• **ENGINE—3.0L 2V (VULCAN)—REVISED OIL PAN GASKET REPLACEMENT PROCEDURE—SERVICE TIP** • **LEAK—ENGINE OIL FROM OIL PAN GASKET AREA PREVIOUSLY REPAIRED—3.0L VULCAN ENGINE ONLY—SERVICE TIP**	**Article No. 01-12-4**

This article is being republished in its entirety to update the service parts and the Service Procedure.

Figure 1 - Article 01-12-4

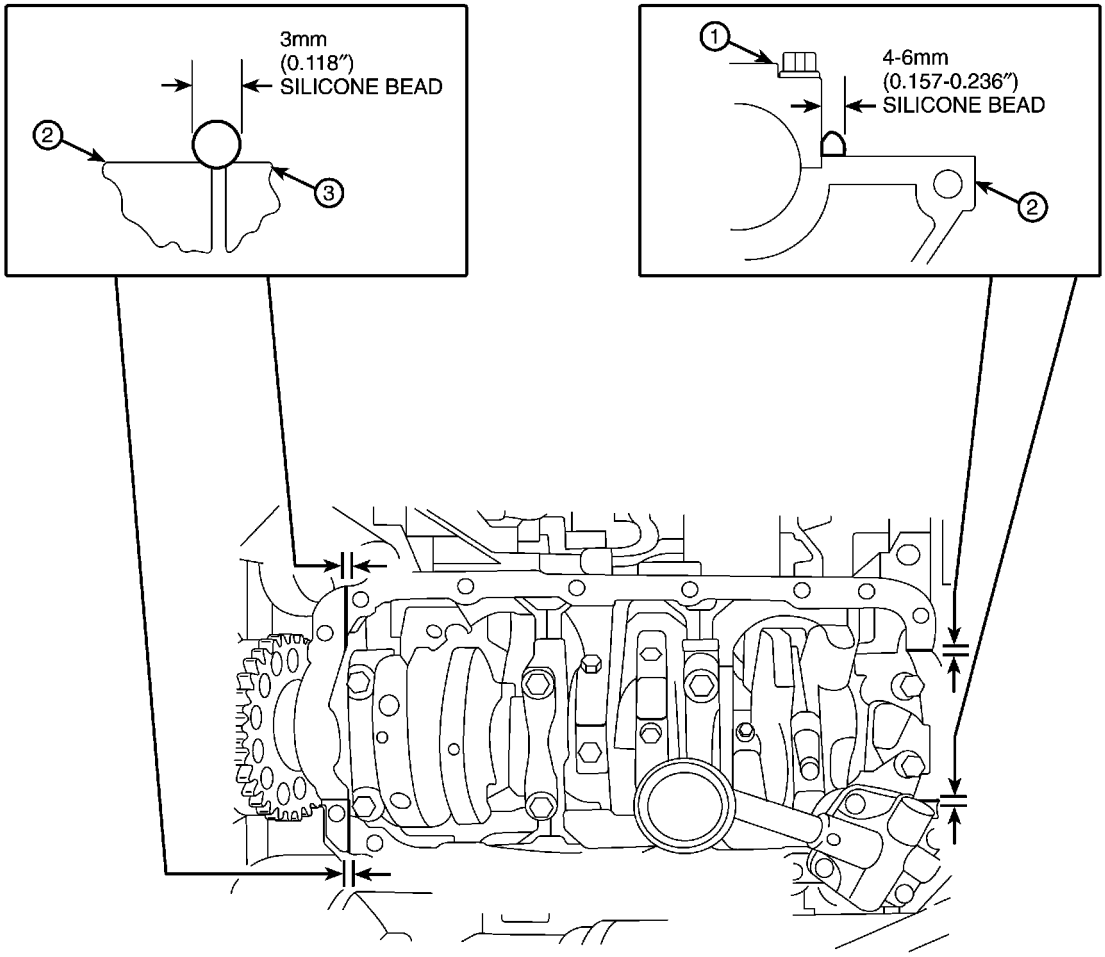
A revised engine oil pan gasket installation procedure is available. Refer to the following Service Procedure for details. Use the contact adhesive listed in the revised installation procedure. A step has been added to recheck the bolt torque after the last tightening procedure and then again after the engine has been run and has reached normal operating temperature. The Step to loosen the bolts one full turn has also been deleted.

1. Remove the oil pan as instructed in the appropriate model year Service or Workshop Manual.
2. Before installing the oil pan, carefully and thoroughly remove all traces of the old RTV sealant from the oil pan and engine block (Figure 1). Refer to the Workshop Manual for the correct metal surface cleaner.

3. To install the oil pan gasket, apply Motorcraft Gasket Adhesive TA-6 (US) or CTA-6 (Canada) meeting Ford Specification WSS-M2G408-A to the top of the gasket (the surface that mates to the engine block), and to the entire engine block sealing surface including the front cover and rear main bearing cap surfaces (Figure 1), but not the front cover-to-block and rear bearing cap-to-block parting lines (Figure 2).
